Attachment G
Exceptions to Design Standards

Fact Sheet Exceptions to Mandatory Design Standards

LAUREN PROCTOR, Registered Civil Engineer
CH2M HILL

**ADVISORY EXCEPTION NO. 5B
MEDIAN WIDTH IS 22 FEET**

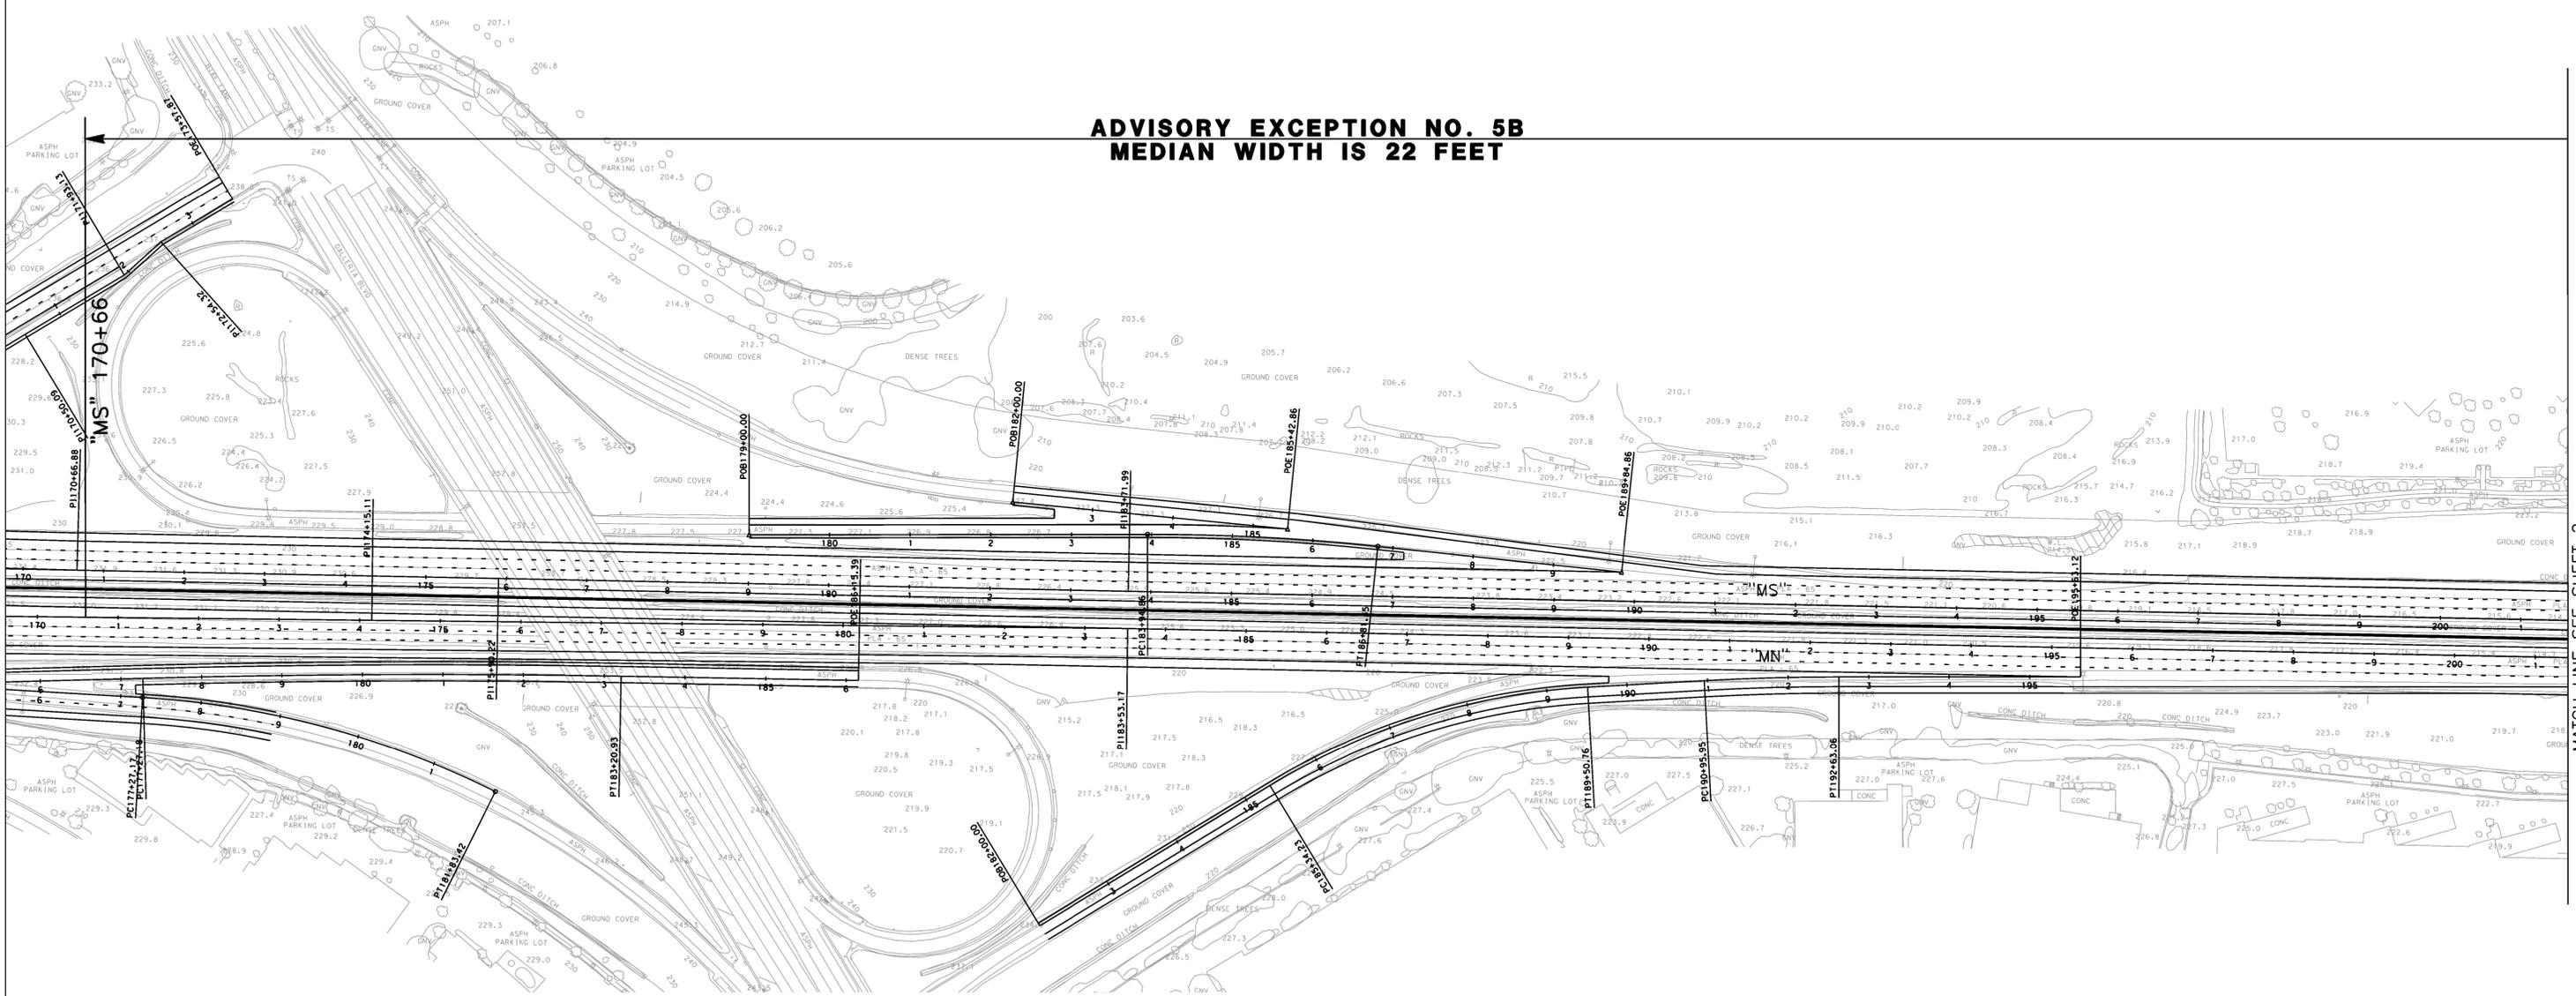
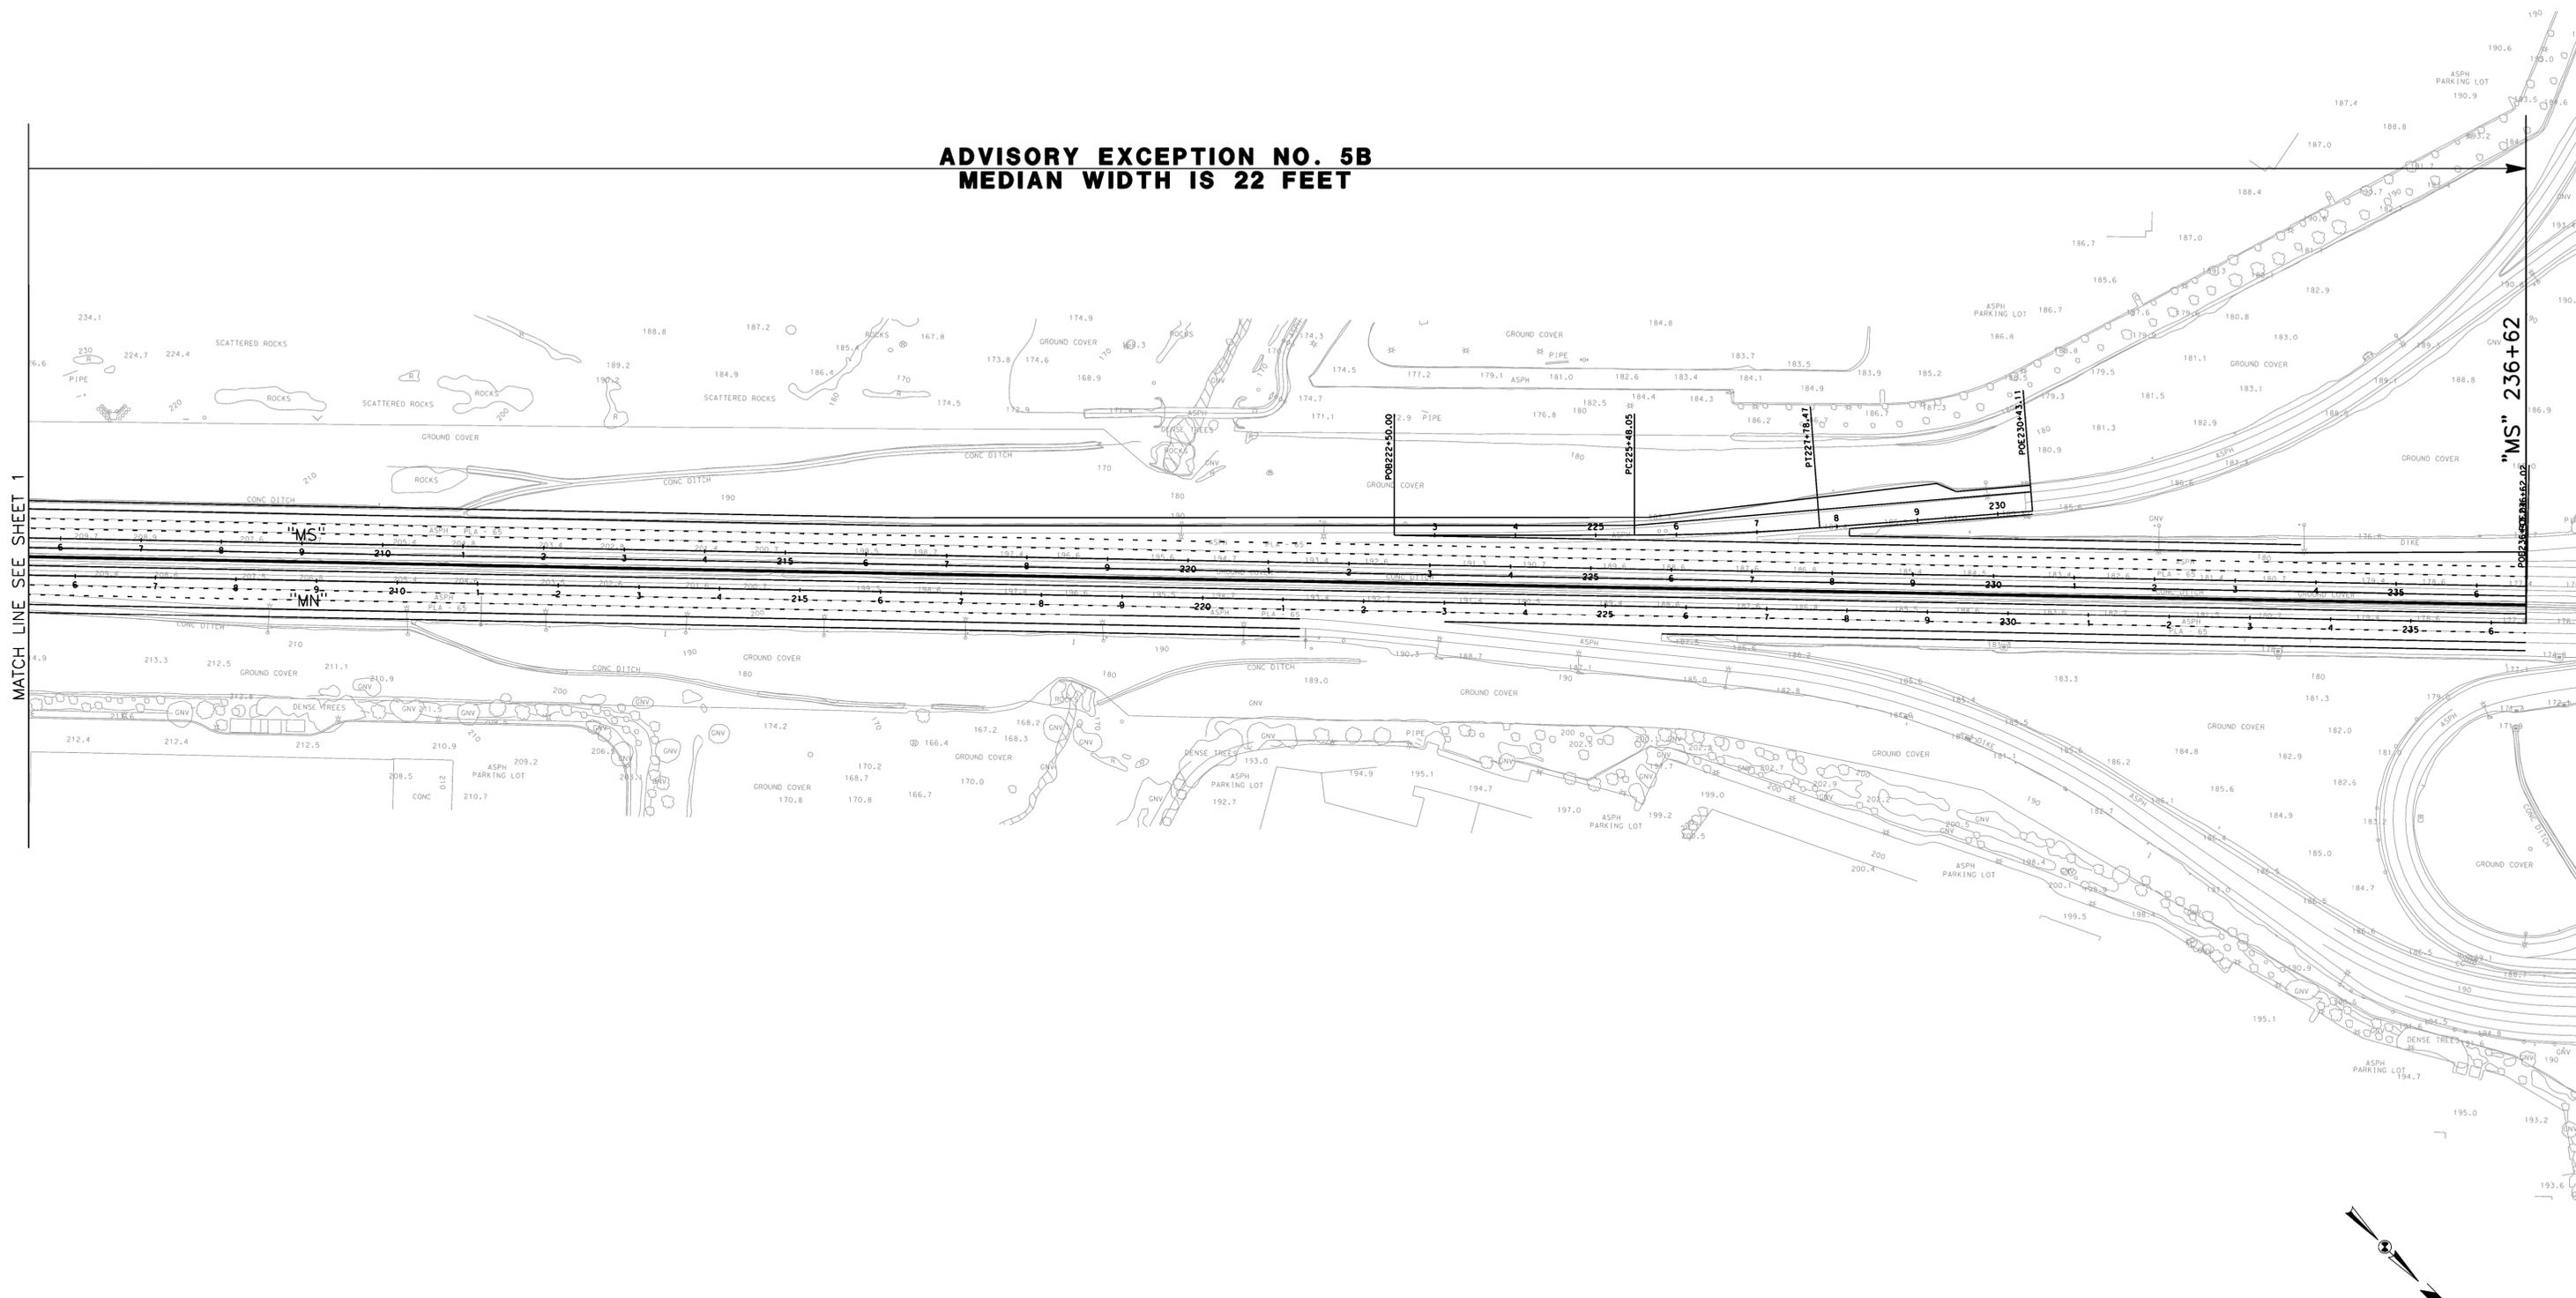
ADVISORY EXCEPTION NO. 5A
MEDIAN WIDTH
VARY FROM 22 FEET TO 36 FEET

Location B: The reason for this design exception is to conform to the existing planned typical section and the proposed SR 65 Capacity and Operations Improvement project, avoiding additional impacts to roadways, structures and property outside the proposed right of way.

Conformance to standard would require reconstructing Galleria Blvd/Stanford Ranch Rd Overcrossing, realigning all ramps, and change the proposed typical section for SR 65 Capacity and Operations Improvement project to 36 feet.
